STD Comment Form for 1st Posting of Balance Resources and Demand Standard

Note – This form is to comment on version 1 of the Balance Resources and Demand Standard.

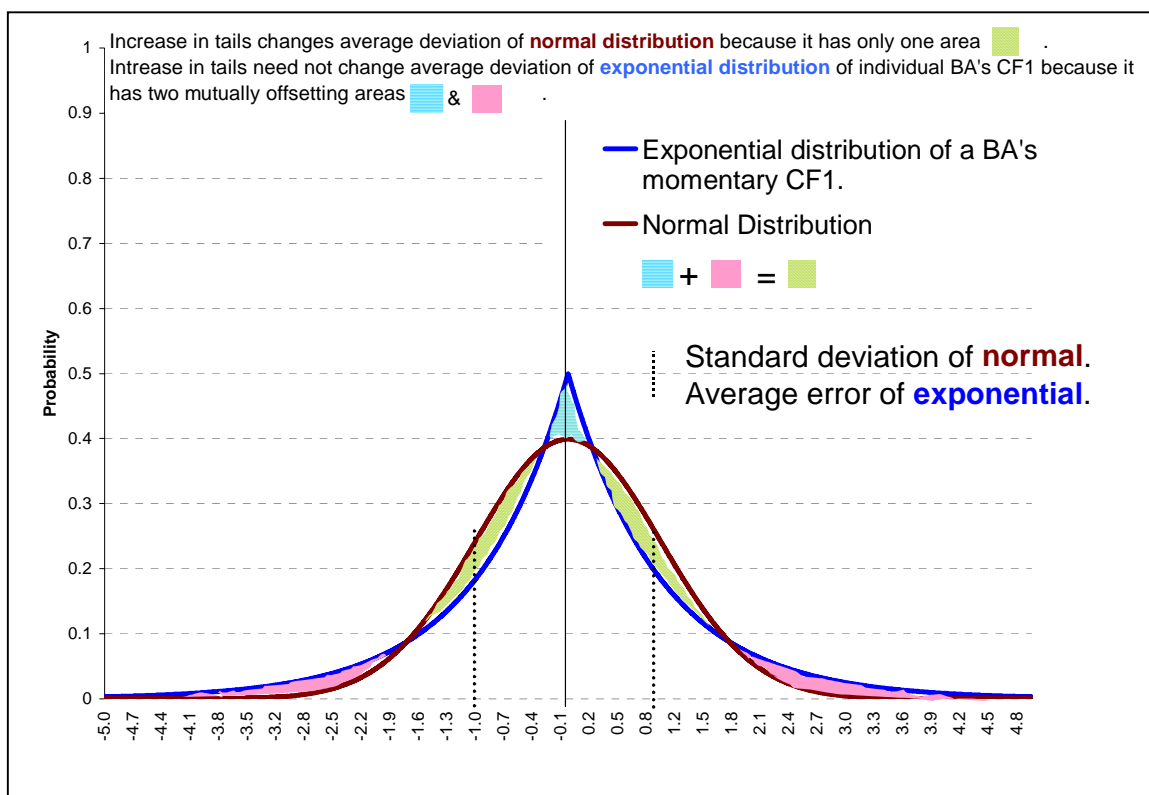
There is no sound technical basis for the DEM concept or the proposed DEM measures, but a monthly CPM1 measure, while better than the proposed DEM measures, would be technically incompatible with annual CPM-1.

NO TECHNICAL BASIS. There is no sound technical basis whatsoever for the compliance threshold value of 15, nor for any value for that matter. It is not an "event" measure at all as formulated: as formulated it detects "*usual operating*" errors. Also it assumes the wrong statistical distribution over time of momentary CPM Compliance Factor performances.

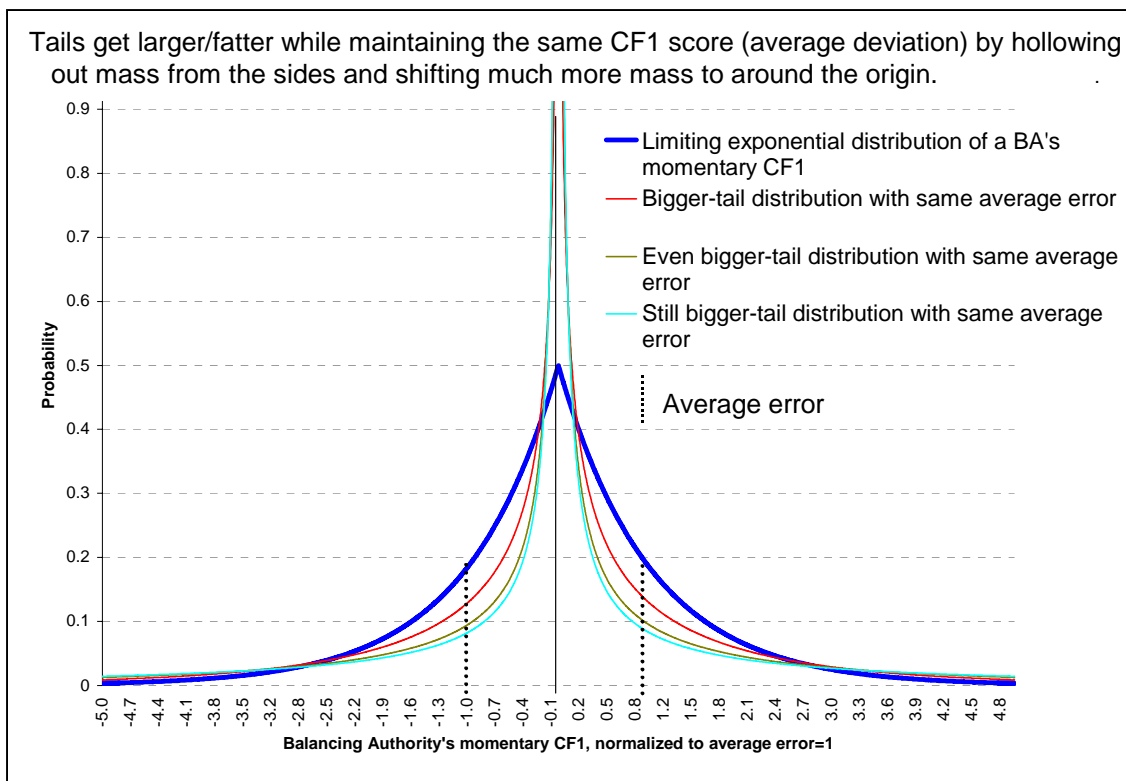
- FOR CPM COMPLIANCE A HUGE NUMBER OF EXTRA TIGHT ERRORS (CF1s) CAN COMPENSATE FOR A BIG MOMENTARY ERROR (CF1).** In other words,
 - A BALANCING AUTHORITY** can maintain the same standard deviation of error when the relative number of his big errors increases as long as the relative number of his tiny errors increases exponentially more. He can expand the base of the volcano while keeping the mass of the volcano unchanged, as long as the funnel of the volcano narrows and spikes ever upward, making the volcano thinner and steeper. In other words, he can make up for big errors by also increasing, but by exponentially more, the proportion of tiny errors, namely by tightening his control of usual operating errors. So the number of big errors he can incur, without deteriorating the standard deviation of

error, is limited by how much he can tighten his control of usual operating errors the rest of the time.

- **FREQUENCY** remains normally distributed at the same standard deviation of error because other Balancing Authorities' tiny errors (ever more frequent if they have had big errors) are simultaneously offsetting a Balancing Authority's big error.

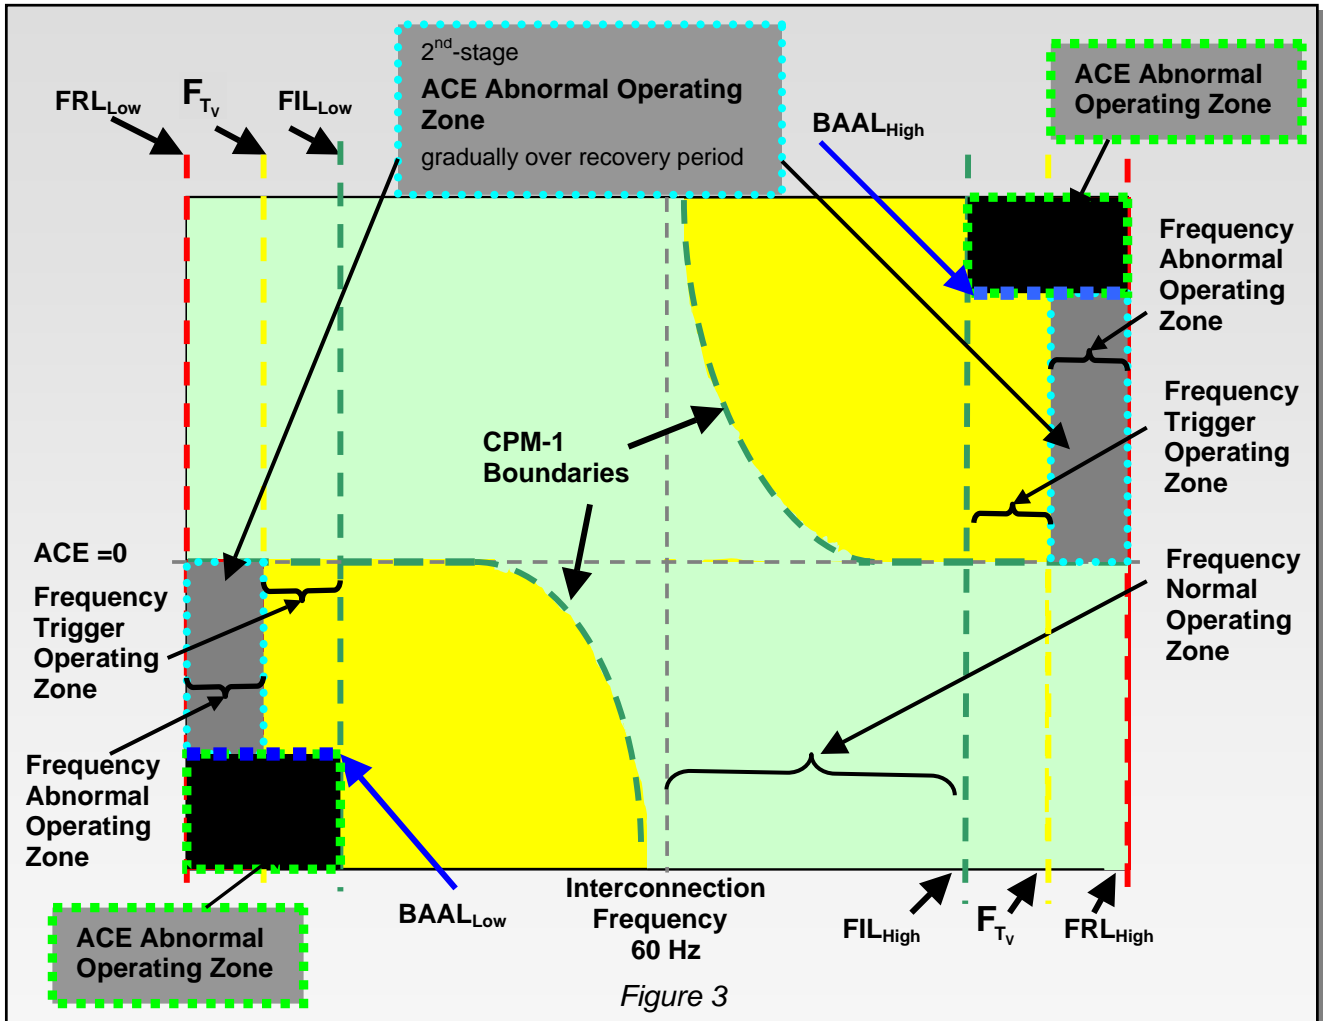
THE REQUIREMENT AND MEASURES ARE UNNECESSARY, and would *unnecessarily complicate compliance* assessment of Balancing Authorities to a 2-dimensional matrix from the presently proposed 1-dimensional scale of %-of-instructed-ACE-reduction performed in section 5 of requirement 304. A non-compliant Balancing Authority's geographic proximity to the other non-compliant Balancing Authorities, reflected in whether the Balancing Authority's Reliability Authority is a cause of the violation, is irrelevant both to that Balancing Authority's impact on Interconnection frequency and to the Reliability Authority's performance of its task. The Reliability Authority has no control over how many of the non-performing Balancing Authorities lie in its jurisdiction. Furthermore, while several Reliability Authorities could collectively be the cause of a violation without each individually being a cause, for example if each contained just one of a number of offending Balancing

Authorities, the violation is no less serious than if one Reliability Authority is the cause. Similarly for the seriousness of a violation, whether caused by a single event, or by a combination of poor operating performances by a group of Balancing Authorities. But second-stage non-compliance is badly defined.

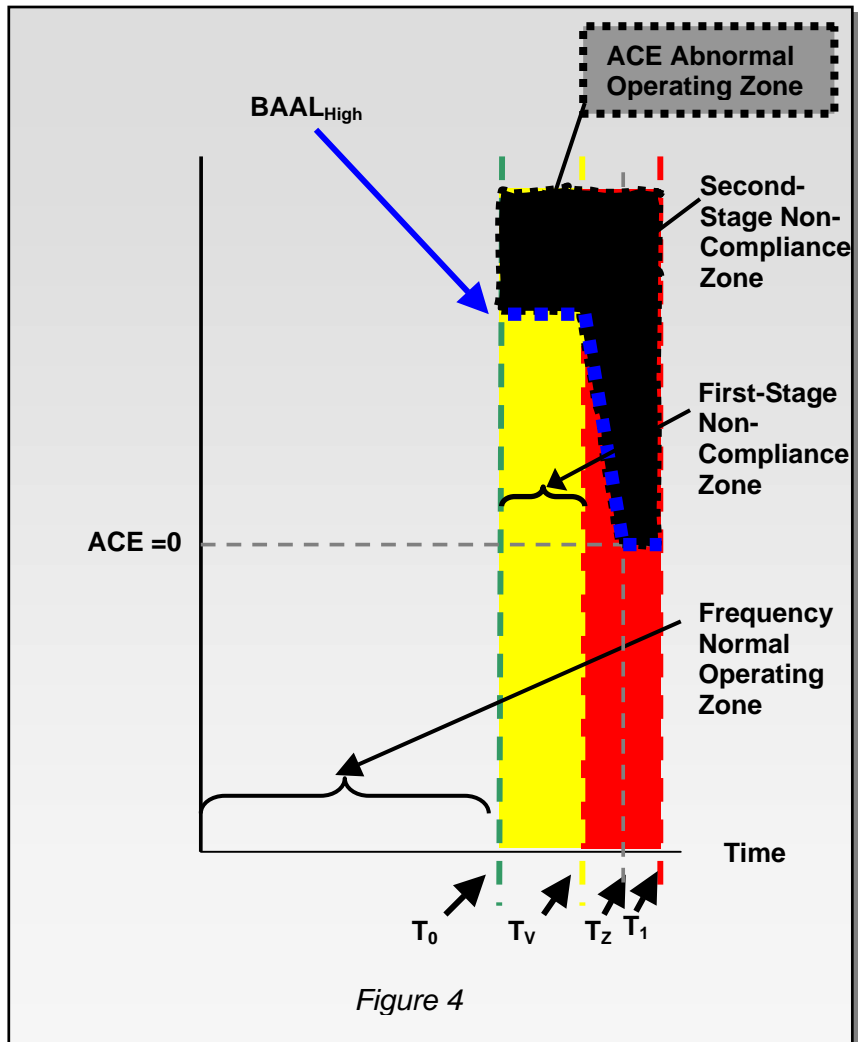
THE SECOND STAGE OF NON-COMPLIANCE BY BALANCING AUTHORITIES IS DISCONTINUOUS AND DESTABILIZING FOR REQUIRING for compliance *instantaneous* elimination of any ACE in the direction of the violation. The second stage of non-compliance occurs whenever the Frequency Abnormal Limit is breached or the recovery time exceeds the Frequency-Limit Violation Time limit. The discontinuity causes frequency instability in two ways:

STIPULATE A SECOND-STAGE ABNORMAL-LIMIT VIOLATION PERIOD AND DEFINE THE "ACE NORMAL OPERATING ZONE" RELATIVE TO FREQUENCY AND RELATIVE TO TIME. The ACE Abnormal Operating Zone over that second-stage abnormal violation period can be defined *only relative to time*, and not relative to frequency, as a diagonal line sloping downward from BAAL at the beginning T_V of the period to $ACE=0$ at T_Z during the period just long enough for Balancing Authorities suddenly non-compliant through no fault of their own to reasonably comply. Accordingly, Figure 3 of the definitions needs to be redrawn to display the ACE Abnormal Operating Zone, to relabel the frequency limits, and to properly depict the CPM-1 boundaries which decay to $ACE=0$ well before reaching the Frequency Trigger Limit (Frequency Intervention Limit, FIL), and a new Figure 4 needs to be added showing ACE relative to time, depicting the ACE Abnormal Operating Zone, and labeling the frequency limits.
